1435 - P045a

Entrance Hall//Existing//Plan_1:20

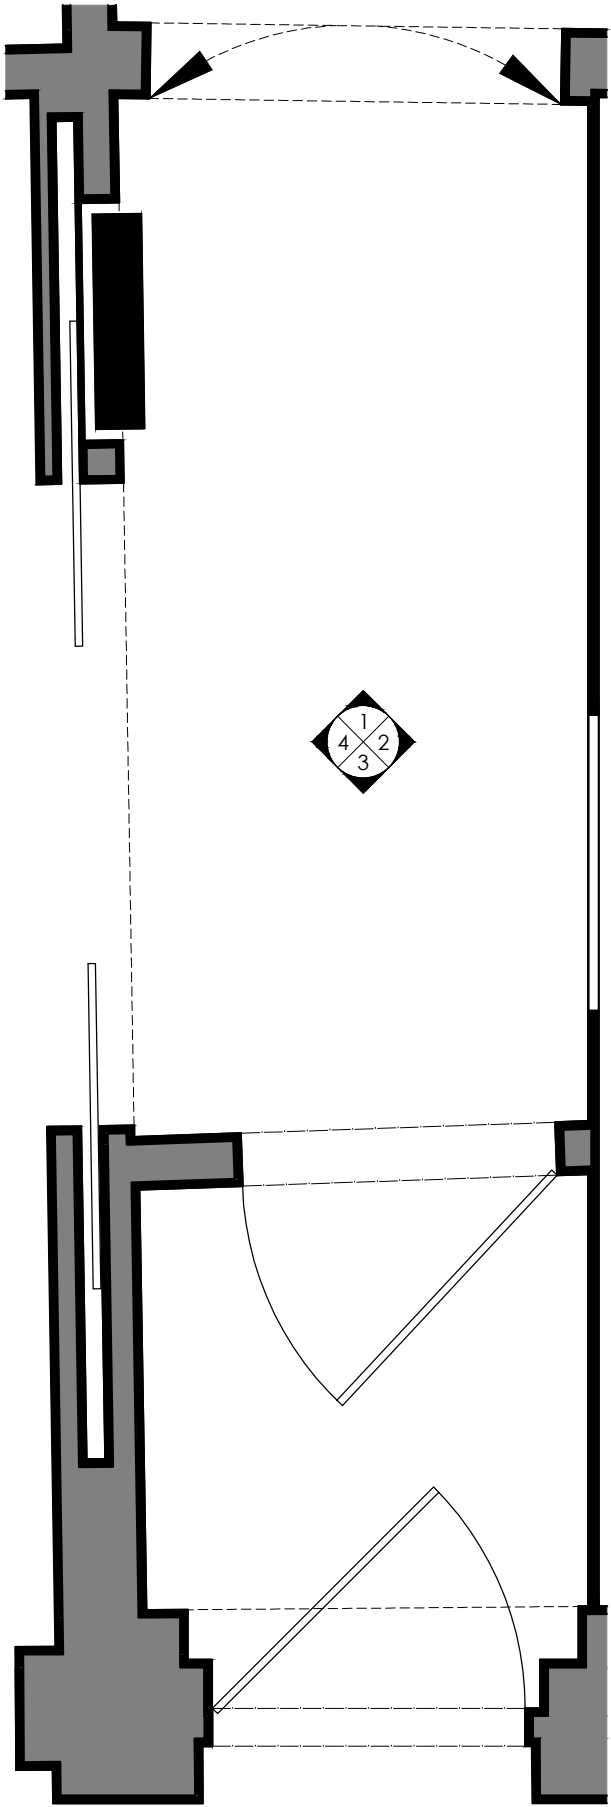
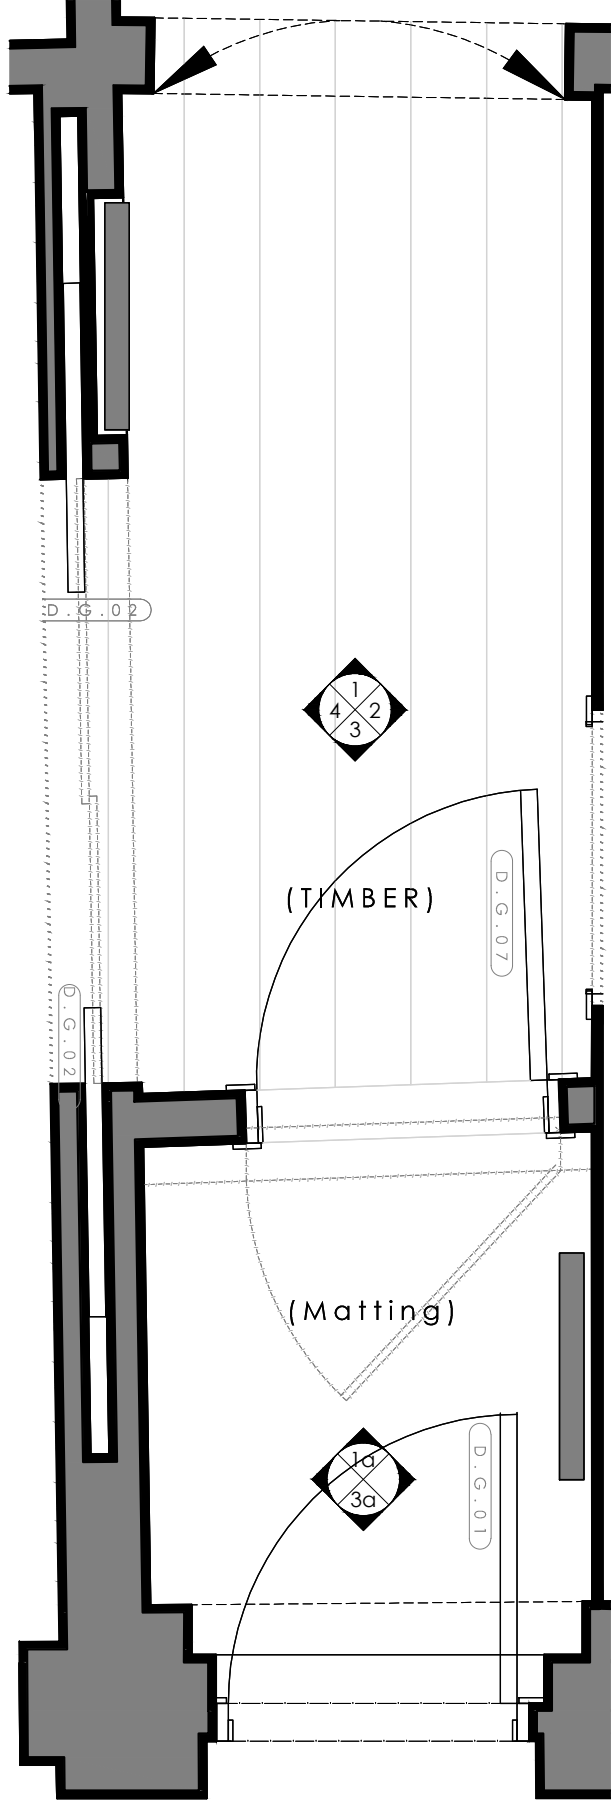
Rev	Date	Notes
A	14.05.15	Drawing revised following comments from council.

Rev	Date	Notes
A	23.06.15	Radiator added.

1435 - P047

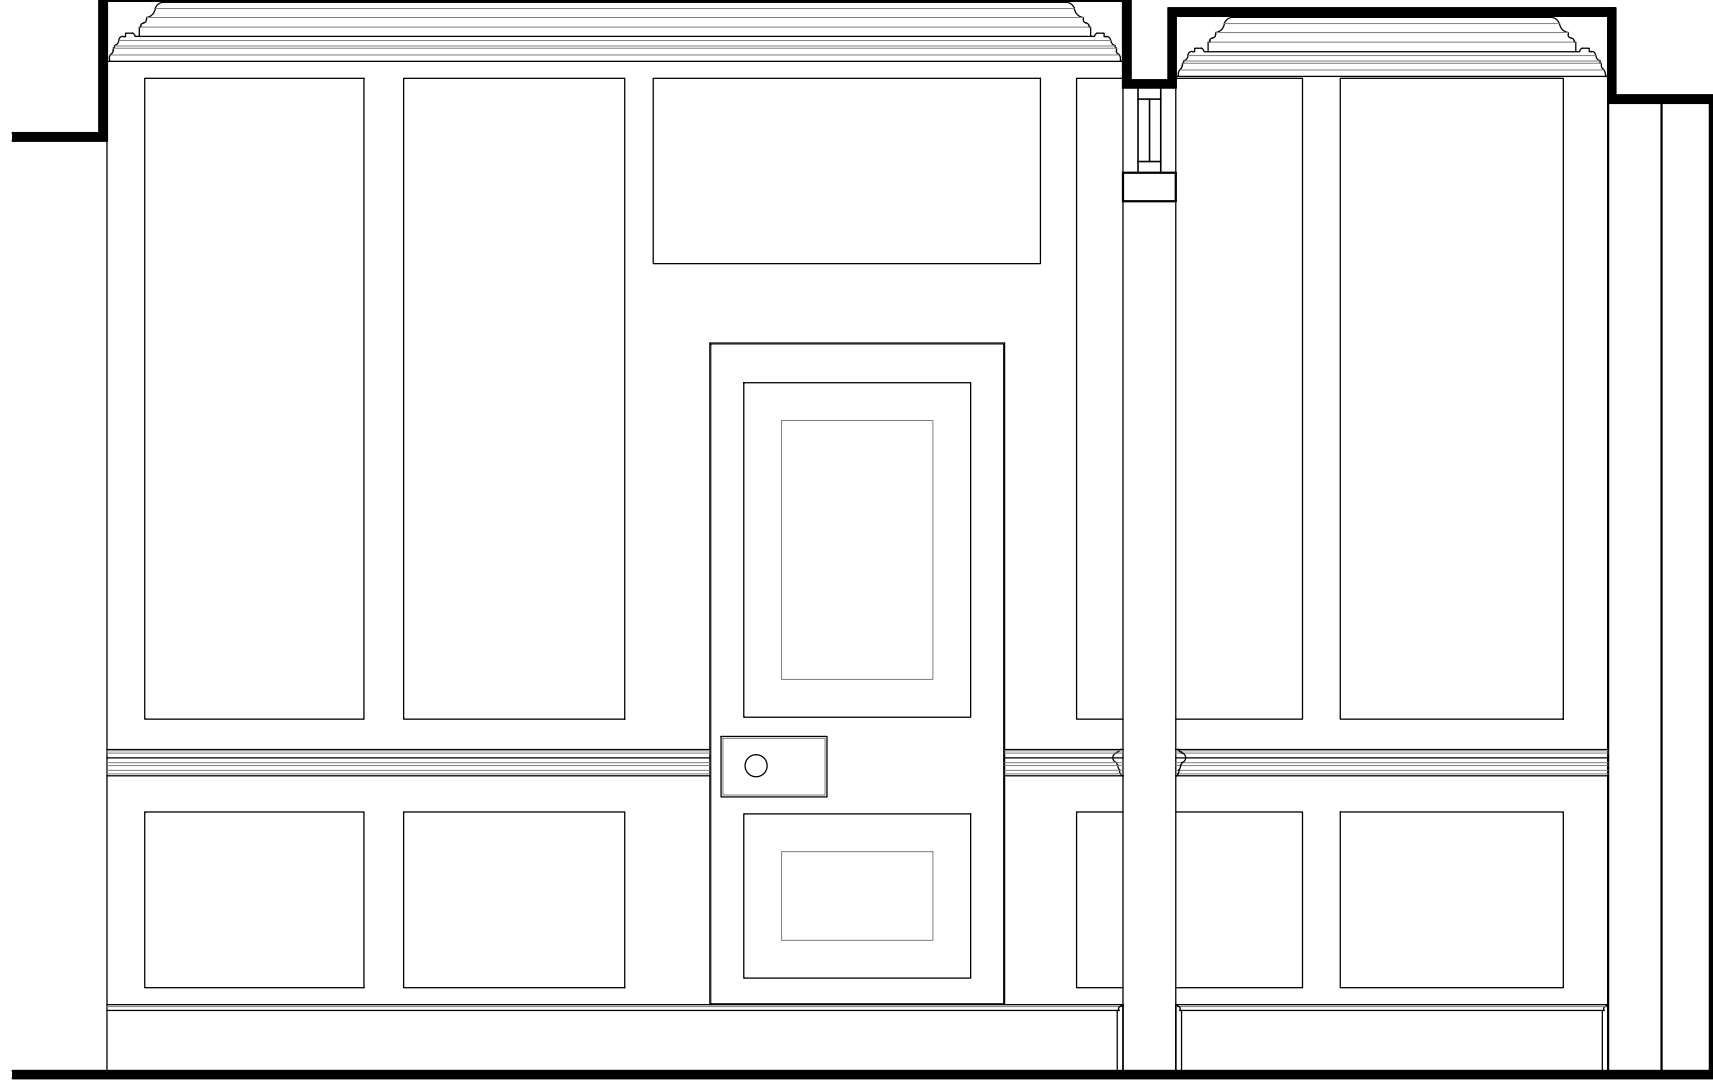
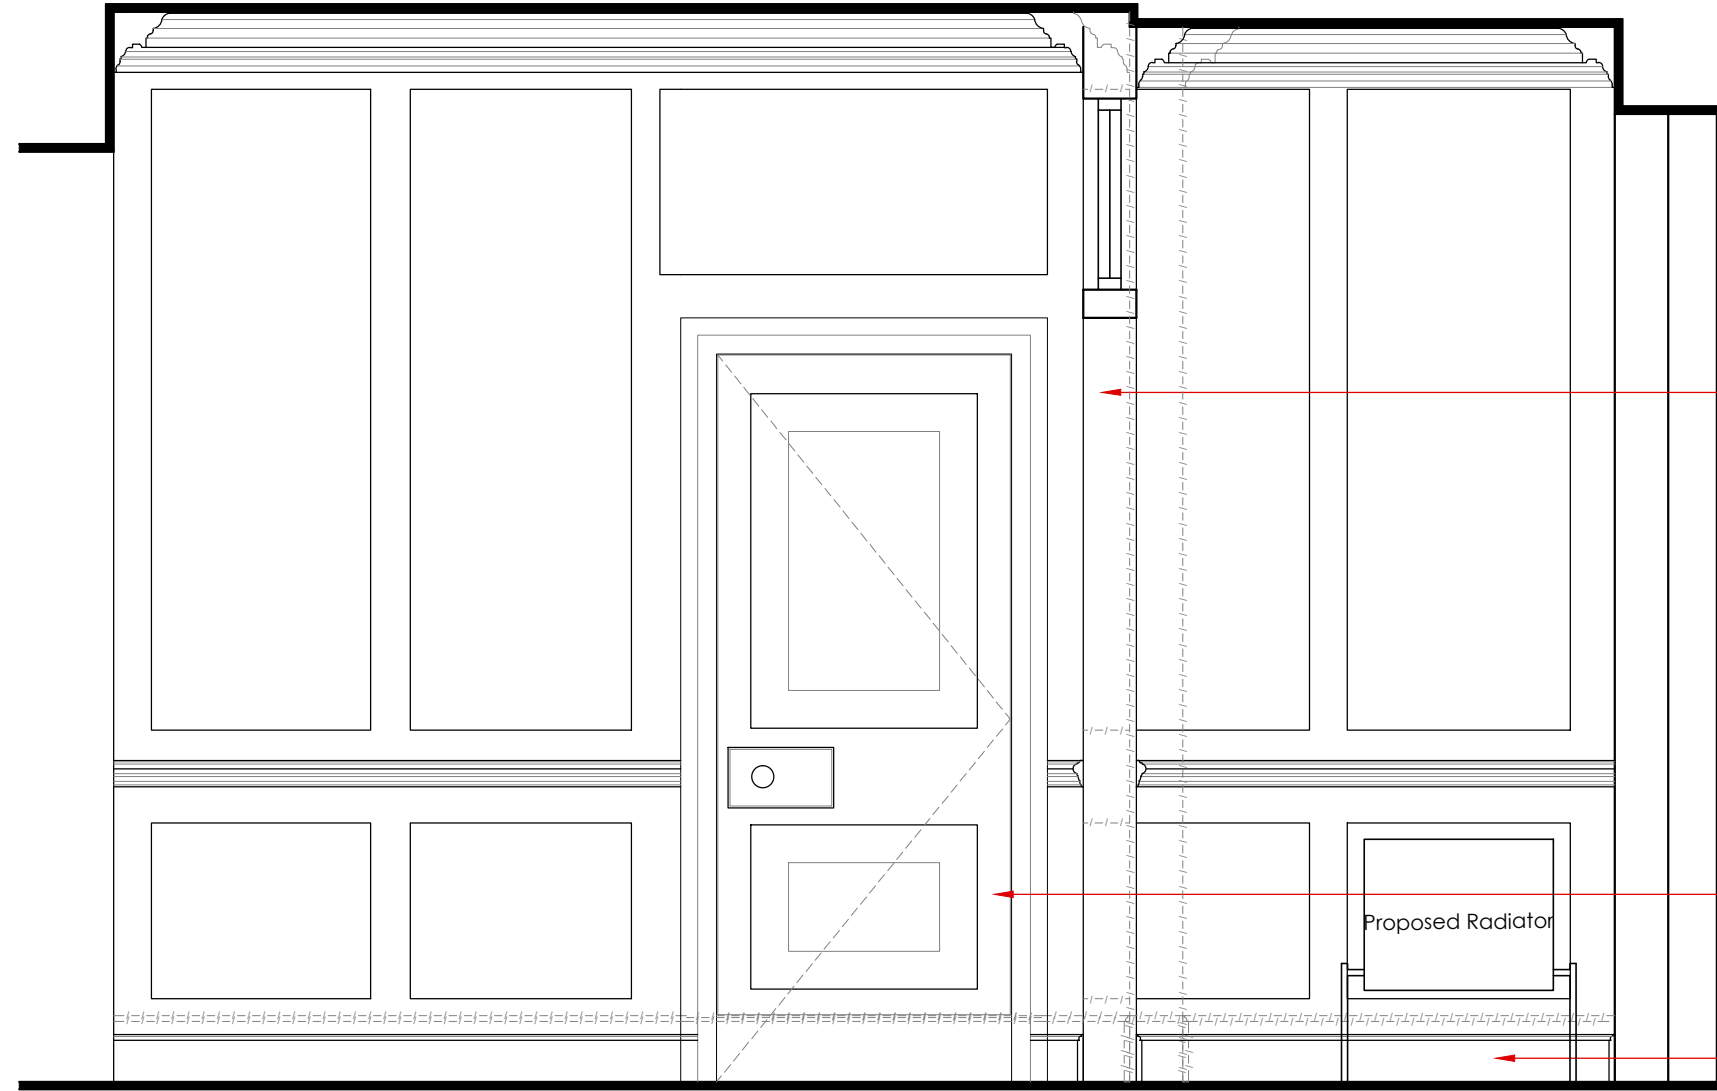
Existing non original door and opening moved to ensure equal panelling. Door to be replaced with 1/2 glazed door. Door swing revised.

Existing door retained.

Existing skirting removed and new skirting proposed to even panelling gaps.

Rev	Date	Notes
A	23.06.15	Radiator added.

1435 - P049

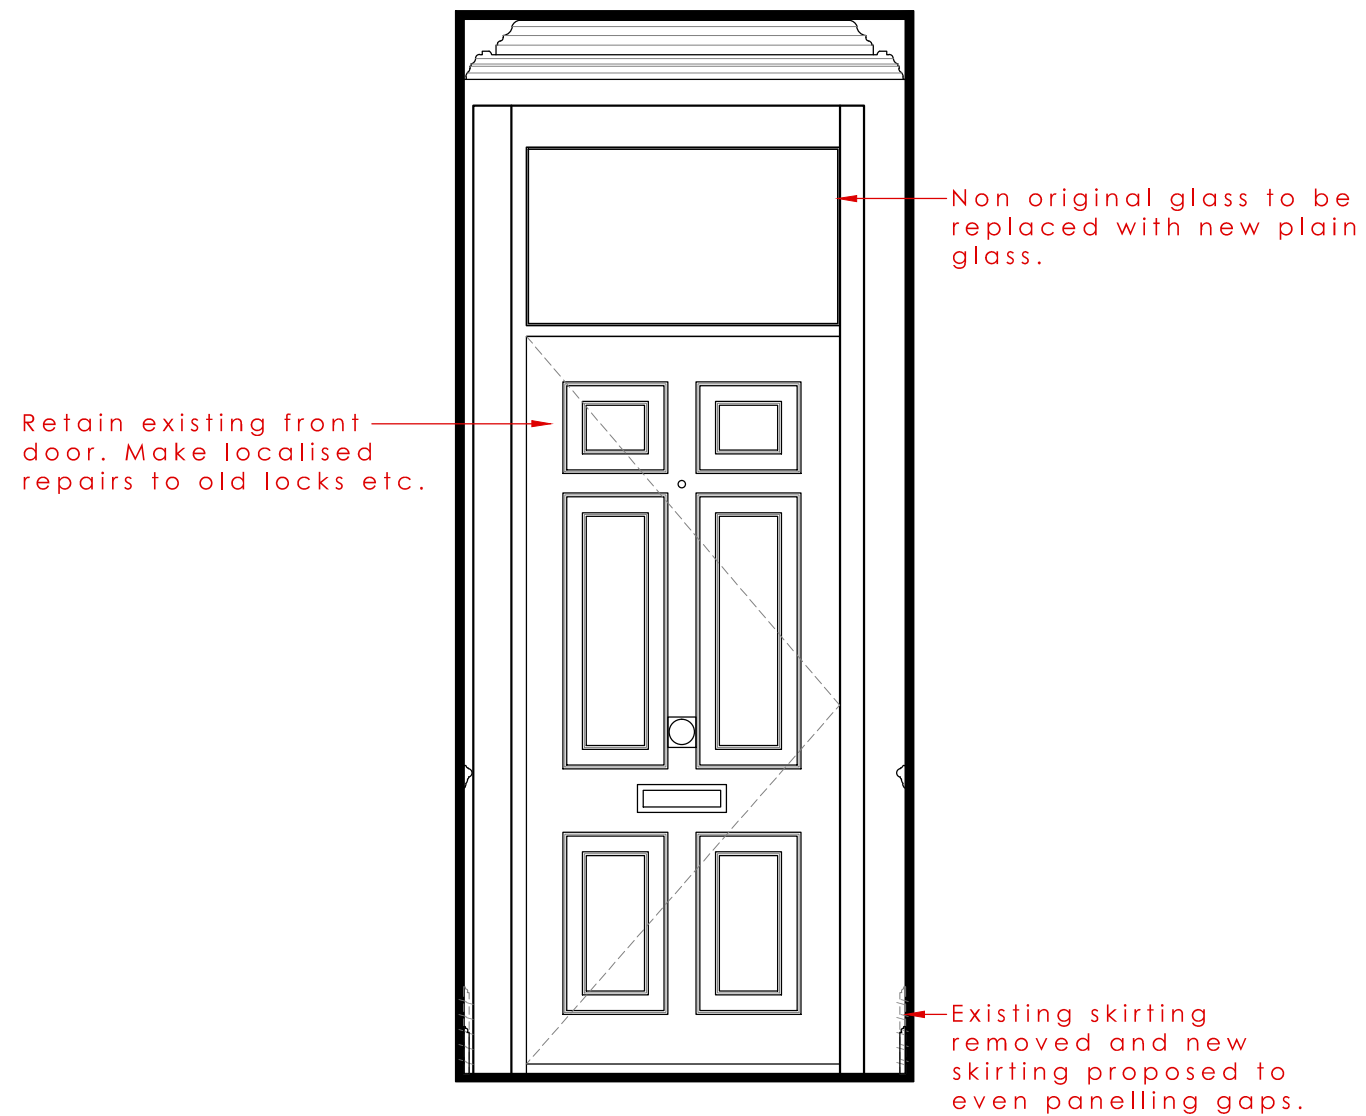
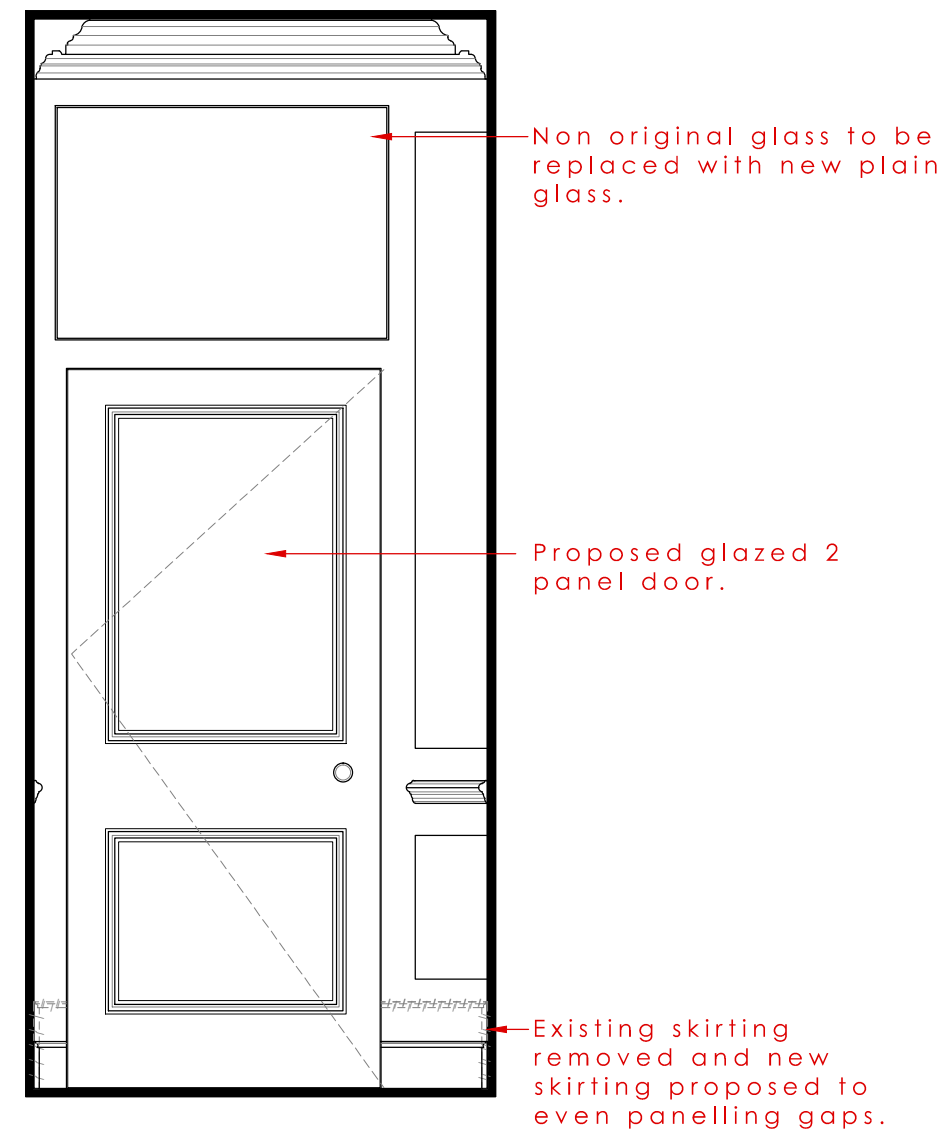
Rev	Date	Notes
A	14.05.15	Note to front door revised following comments from council.

Existing skirting removed and new skirting proposed to even panelling gaps.

Existing panelling retained.

Proposed opening to be centralized and head height raised to suit panelling. Doors to match D.G.06. New sliding mechanism.

Proposed Radiator

Rev	Date	Notes
A	23.06.15	Radiator added.
